REQUEST FOR INFORMATION

Project Name:	6 Bears & A Goat	R.F.I. Number: 006
Project No:	16136	From: Corinna Grogan
To:	Stacey Lampman	Date: 7-21-16 Requested Return
	Kelly Penick Revisions to New/Existing Slab	Date: 7-22-16
Re:	Connections	Contract For: 6 Bears & a Goat
Specification Sectio	n: n/a Paragraph: n/a Draw	ing Reference: S-3 Detail: 10

REVISED PERMIT SET DATED 7-8-16

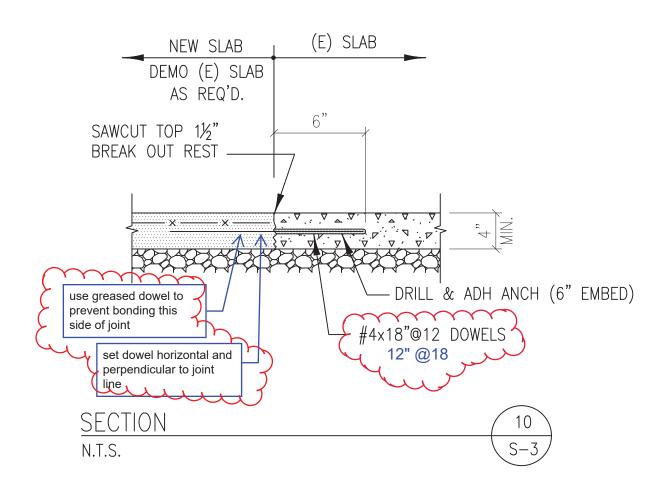
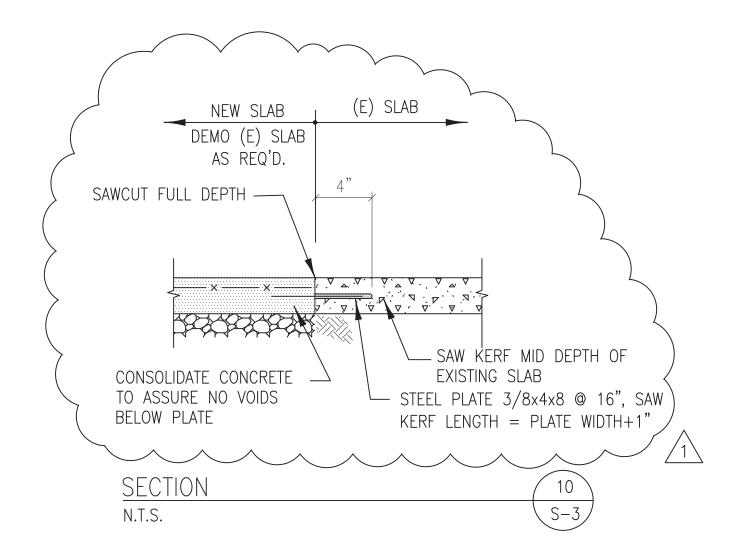
Detail 10/S3.1 on the Permit set dated 6-22-16 (Sheet 1) called for #4 - 12" rebar at 18" o.c. at the connection from the old slab to the new. The revised detail dated 7-12-16 (Sheet 2) calls for 3/8x4x81" wide Steel plates at 16" o.c. Please confirm that additional steel requirement vs. rebar is necessary.

Use revised detail (7/8) or original (6/22) detail 10/S-3 as ammended below with notes for 12"@18 o.c., greased dowel, set perpendicular to joint line.
